Environmental Assessment Response to Submissions

Angus Place Colliery, NSW

Modification of Project Approval 06_0021

April 2011

Figure 2 Area 300 Cross Sections
Showing Surface & Seam Levels
along Lambs Creek

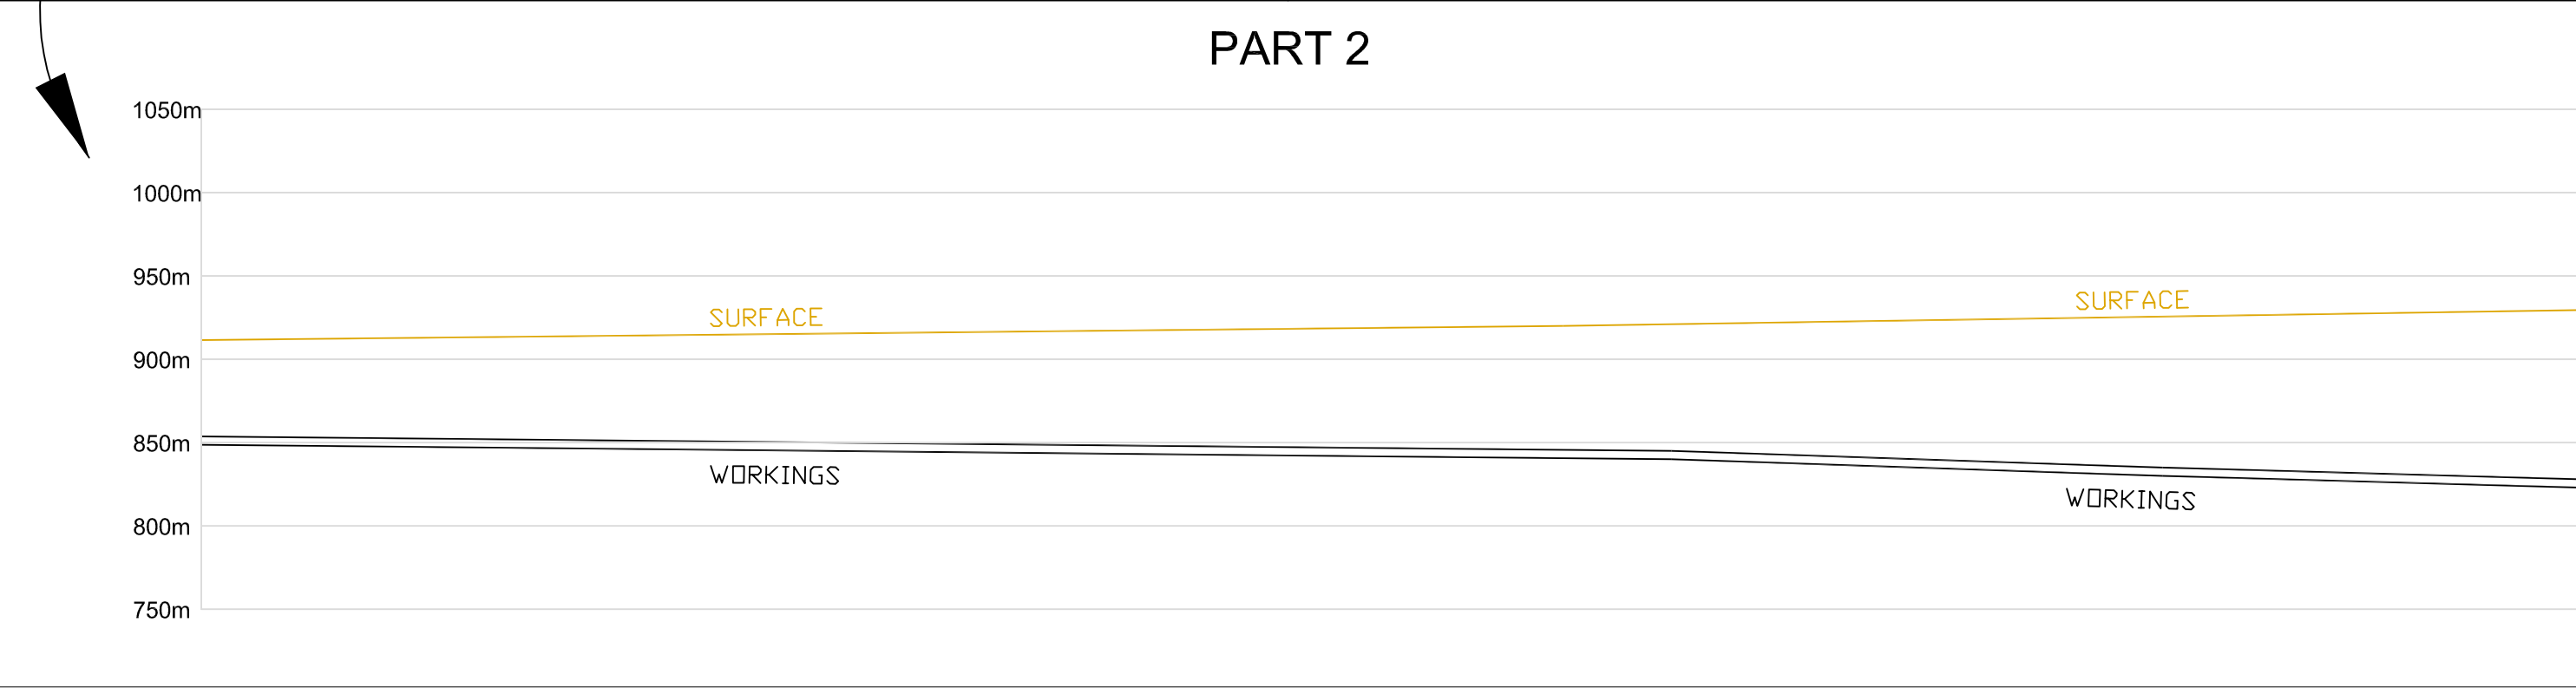
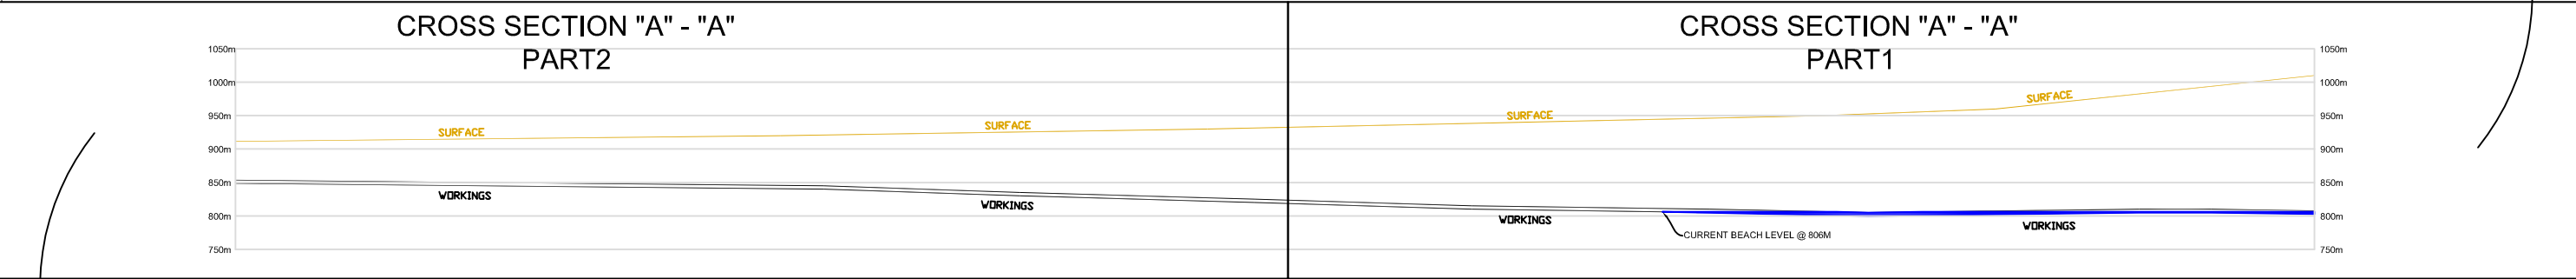
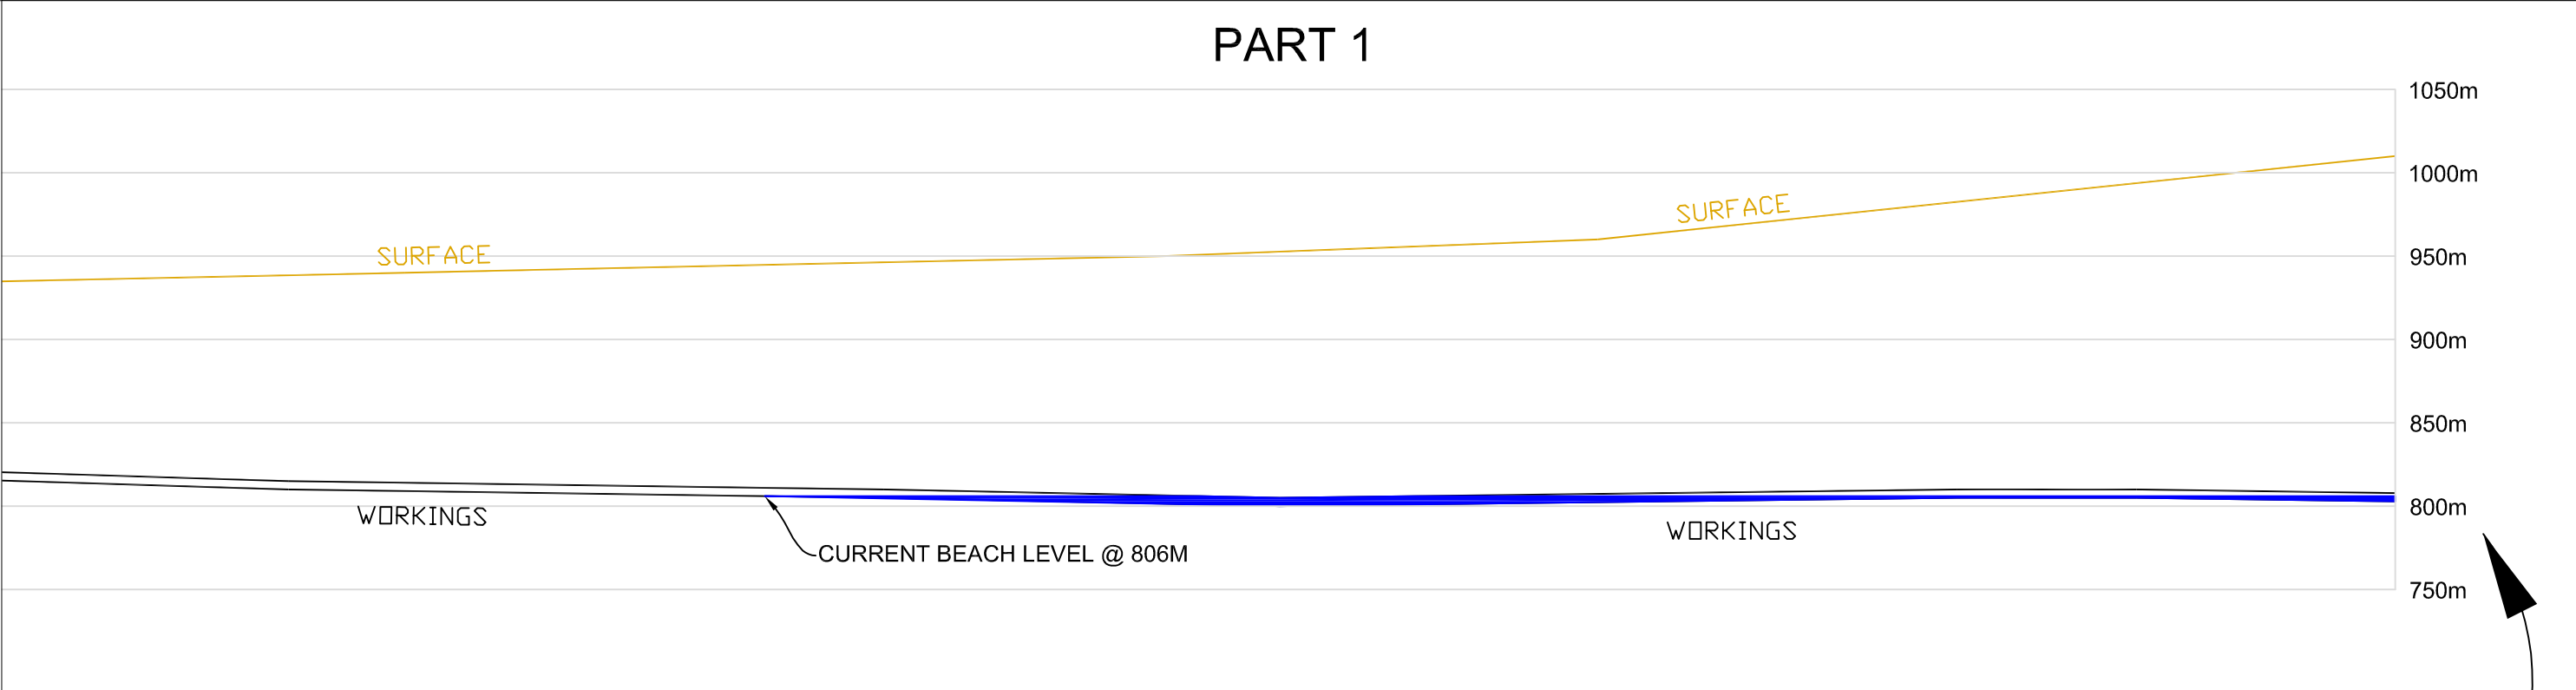
22	CFW	Clarification of discharge from underground water storage in Area 300.	Water from the working face area is pumped to the 300 area where it is allowed to settle (see Appendix 7.3 Surface Water Assessment of the Environmental Assessment). From here it is pumped to the pit top where it passes through several control devices prior to discharge to Kangaroo Creek via LDP001. It is not considered possible for water stored within the 300 area to discharge to Lamb's Creek as the level of the workings is below the surface level and it is not under pressure. The level of the seam beneath Lamb's Creek ranges from approximately 80 – 200m below the surface level as shown on Figures 1 and 2.
23	DECCW	Centennial to make an application to DECCW to vary EPL 467 to align with the proposed modification.	Angus Place Colliery will apply to update EPL 467 to align with the proposed modifications.
